SUBJECT: RECALL R10SB TRW INTERMEDIATE STEERING SHAFT WELD

Recall R10SB TRW Intermediate Steering Shaft Assembly Inspection Reply Sheet

IGEN 3 Intermediate Shaft Weld Location Inspection Procedure

TRW IGEN3 Intermediate Steering Shaft Assembly

Figure 3

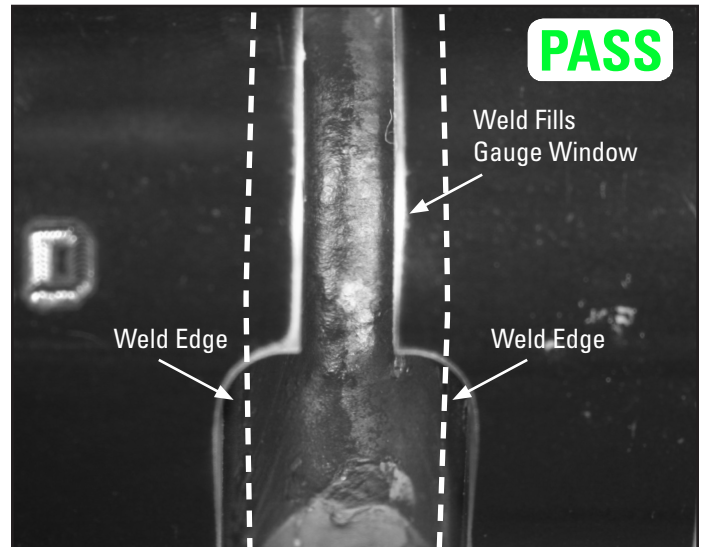
1. Check the weld position using the TRW gauge (SEE Tools Required Page 1). Place the template end of the gauge against the base of the boot seal as shown in **Figure 3** with the gauge placed over the top of the part number stamp location.

Figure 4

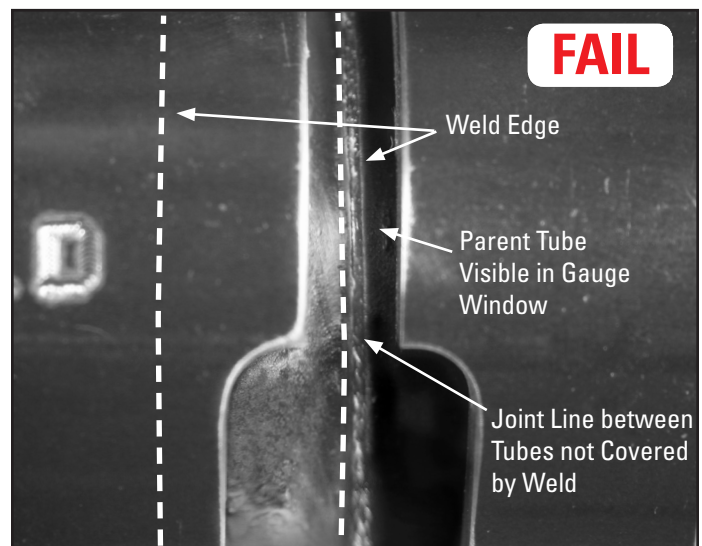
2. Visually inspect the position of the weld bead in reference to the small gauge window (3/16" width). The full circumference of weld seam must be inspected in the gauge window. **Figure 4**

- 2a. **Part Passes** if the weld bead completely fills the narrow gauge window **Figure 4**. Mark the parts that pass inspection with yellow or white paint mark adjacent to the part number stamp.

TRW Inspection Tools

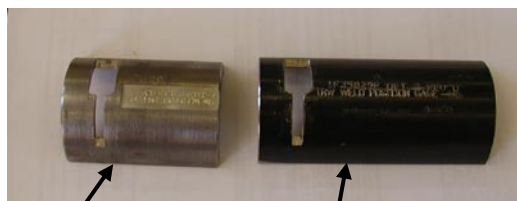
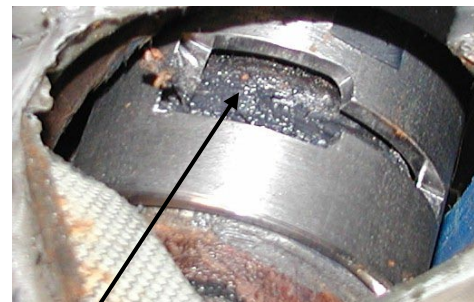
10. The window for the inspection will be visible from underneath driver's floor. Rotate the shaft by turning the steering wheel to inspect weld per TRW Service Procedure # COL-201. If the part passes, follow TRW Service Procedure # COL-201 and then mark the Blue Bird Sheet. If the part fails, mark the sheet and return to the Blue Bird Recall Administrator. **NOTE:** If the weld cannot be seen in the installed position, remove the shaft for inspection. New fasteners **MUST** be use to reinstall the shaft.

Date Code Location

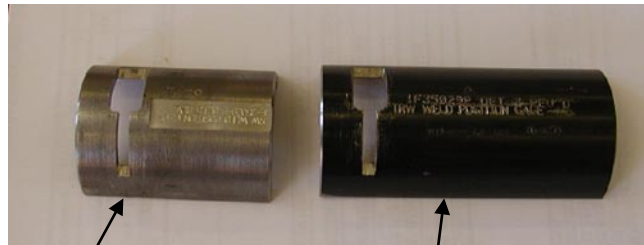
5. The lower shaft TRW date code identification stamped on the shaft is located on steering gear end of the shaft. Turn the steering wheel to rotate shaft for stamped number to be visible.

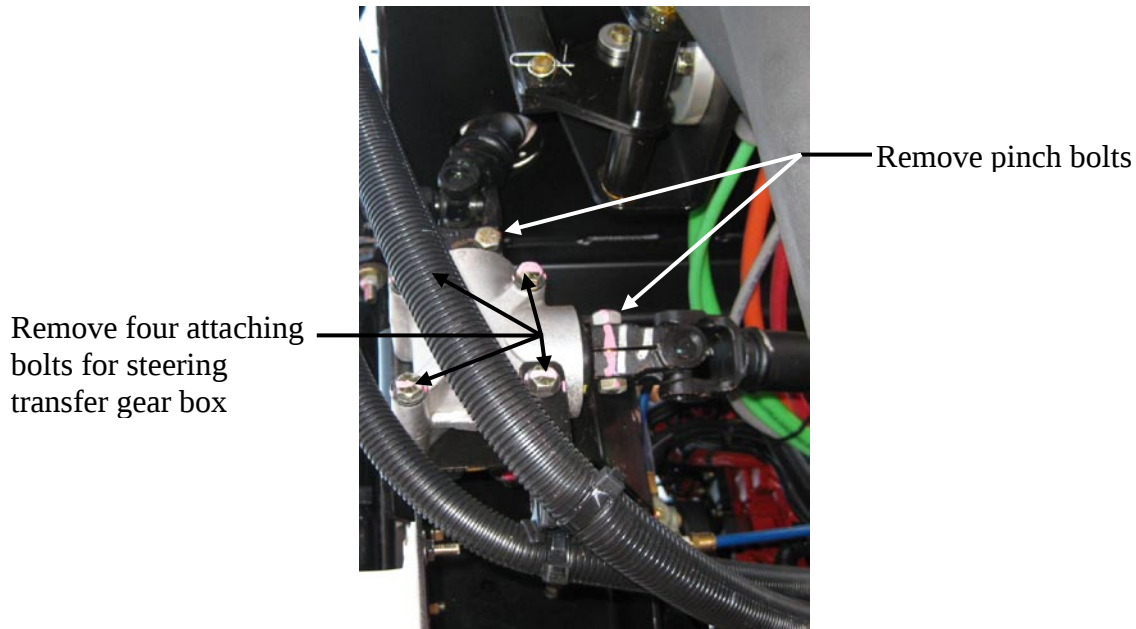
2. Disconnect batteries by removing the negative cable first.
3. Remove the shaft cover by removing two cap screws.
4. Remove four (4) Phillip head screws from trim ring and shaft seal.
5. Remove and discard the pinch bolt and nut from the bottom of steering column.

Remove two capscrews and
shaft cover to access pinch bolt

Remove four screws from
ring, lift ring and remove
shaft seal.

Shown with pinch
bolt removed
